CLEVELAND NATIONAL FOREST POWER LINE REPLACEMENT PROJECTS

MINOR PROJECT REFINEMENT REQUEST FORM

Date Submitted:	03-07-19	Request #:	028
Date Approval Required:	03-12-19	Landowner:	XXX
APN:	XXX-XXX-XX		
Refinement from (check all that apply):			
<input type="checkbox"/> Mitigation Measure	<input type="checkbox"/> APM	<input checked="" type="checkbox"/> Project Description	<input type="checkbox"/> Drawing <input checked="" type="checkbox"/> Other
Identify source (mitigation measure, project description, etc.):			
<p>Notice to Proceed (NTP) request #15 and Minor Project Refinement (MPR) request #18 for the Cleveland National Forest Power Line Replacement Projects (Project) were approved by the California Public Utilities Commission (CPUC) and United States Forest Service on August 30, 2018. Since the approval of NTP request #15 and MPR request #18, San Diego Gas & Electric Company (SDG&E) has determined that the installation of new underground service at Poles P42735, P222133, and P222132 on Circuit (C) 449 is required in order to complete the Project based on changes to AT&T's revised plan for co-location. A brief description and a justification of the refinements are provided on p

**Attachment B:
Comparison Map
C449 Map 1 of 1**

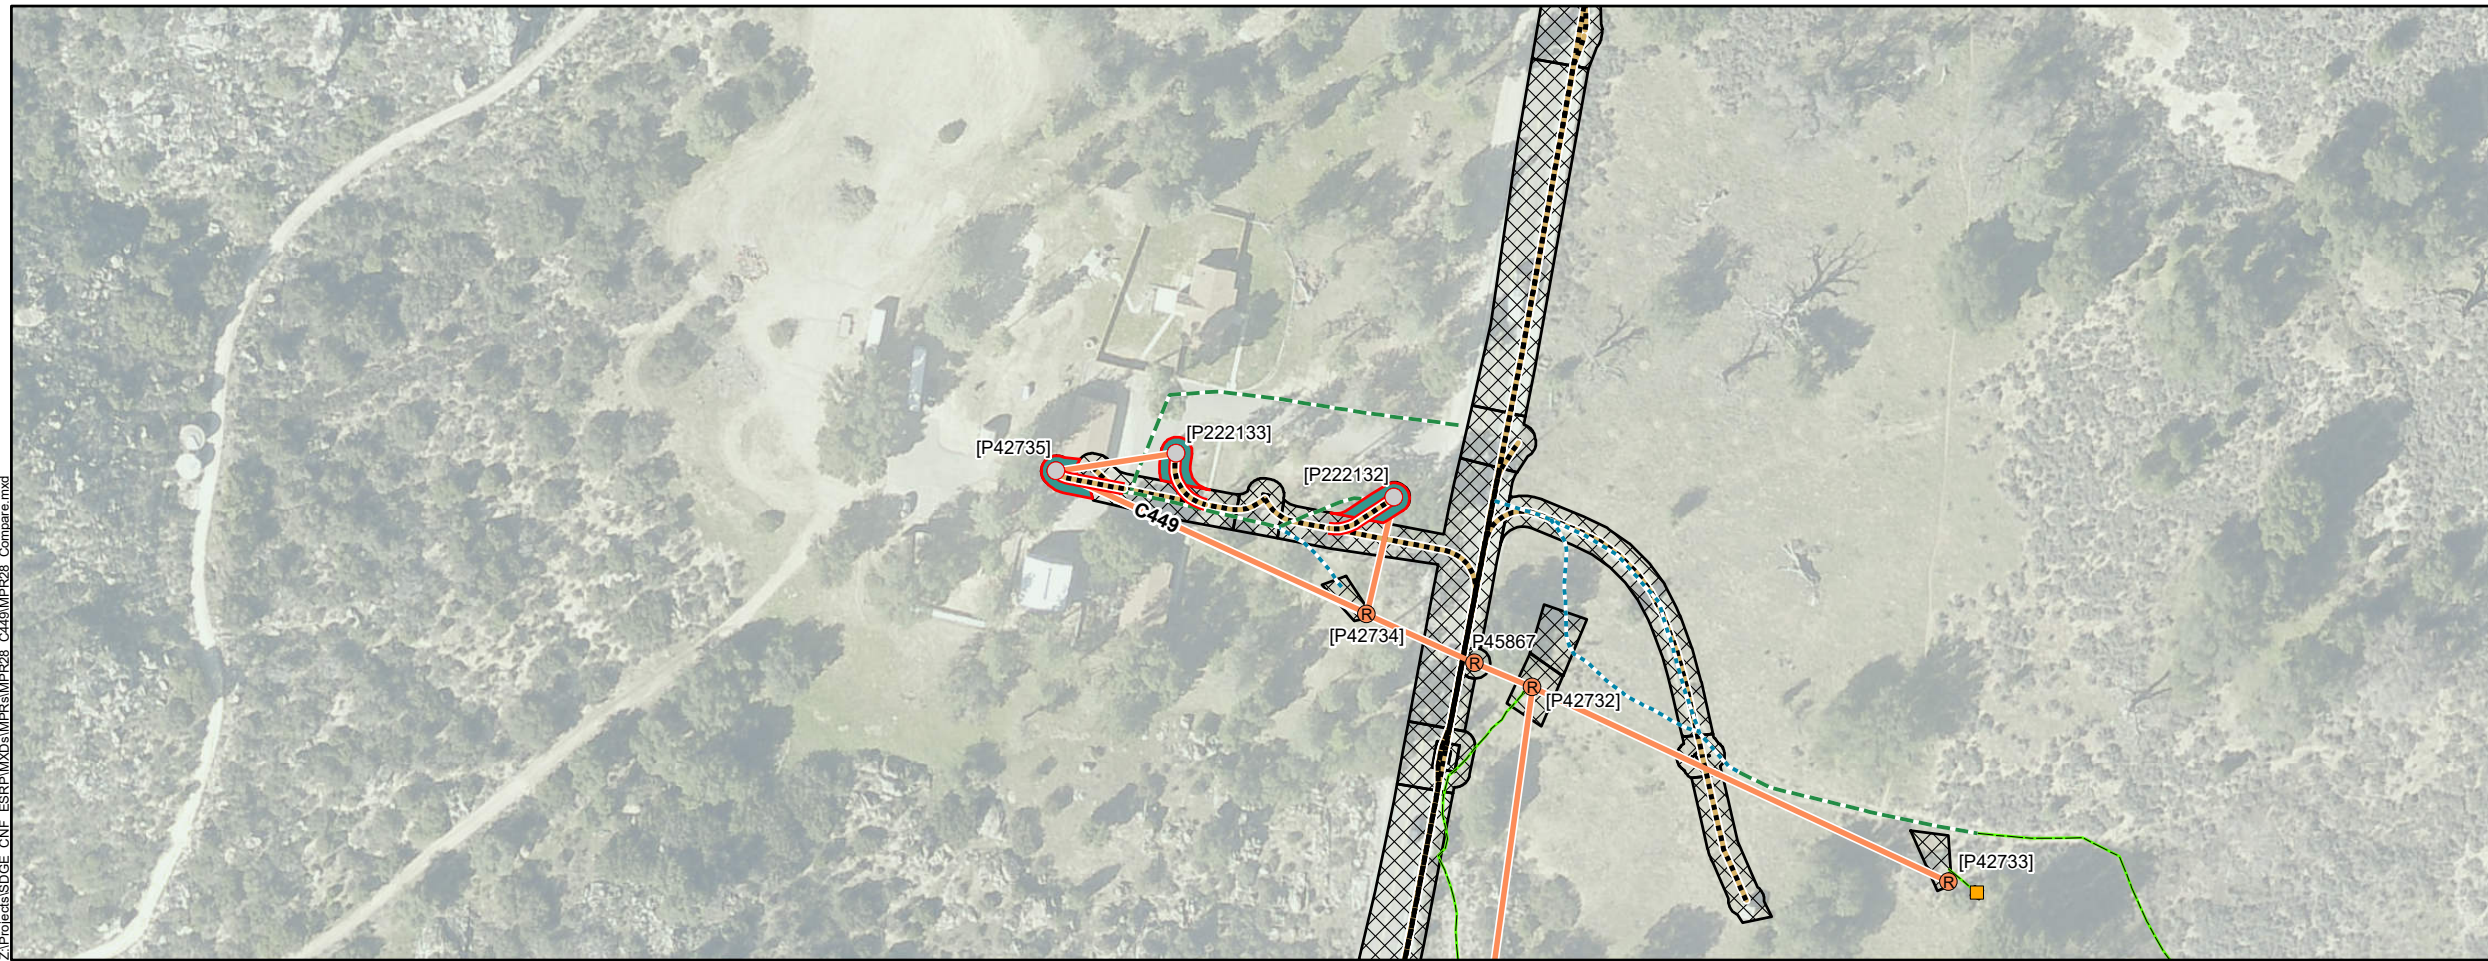
(d) Does the proposed refinement trigger an additional permit requirement?		<input type="checkbox"/> Yes	<input checked="" type="checkbox"/> No
Describe refinement being requested (attach drawings and photos as needed):			
As depicted in Attachment B: Comparison Map and Attachment C: Photographs, SDG&E is requesting additional temporary underground workspaces at the existing Poles P42735, P222133, and P222132 to complete the installation of new underground service. Installation of new underground service will require the construction of new trench lines extending from approximately station (STA) 102+68 of the approved underground alignment to Pole P42735; STA 102+00 of the approved alignment to Pole P222133; and STA 101+16 of the approved alignment to Pole P222132. Poles P42735, P222133, and P222132 were all previously approved as removal poles, but need to be changed to pole-top work only poles so they can be used as light poles for the Cottonwood Fire Station and continue to support AT&T facilities. The requested refinements will result in an increase of approximately 0.02 acre of temporary impacts. The activities associated with the installation of the new underground will occur in the same manner as described in the Final EIR/EIS for construction of the Project.

Provide need for refinement (attach drawings and photos as needed):			
SDG&E is requesting additional temporary underground workspaces for the installation of new underground service in order to complete the Project-based changes in AT&T's revised plan for co-location. The requested refinements will allow for continued support of AT&T's facilities and use of the existing Poles P42735, P222133, and P222132 as light poles for the Cottonwood Fire Station, which are required to complete C449 as currently designed.			
Date refinement is expected to be implemented:		03-13-19	
Resource Agency Coordination			
Resource Agency	Name	Action Required	Date
Documentation (see attached if yes)			
Not Applicable (N/A)	N/A	N/A	N/A
<input type="checkbox"/> Yes	<input type="checkbox"/> No
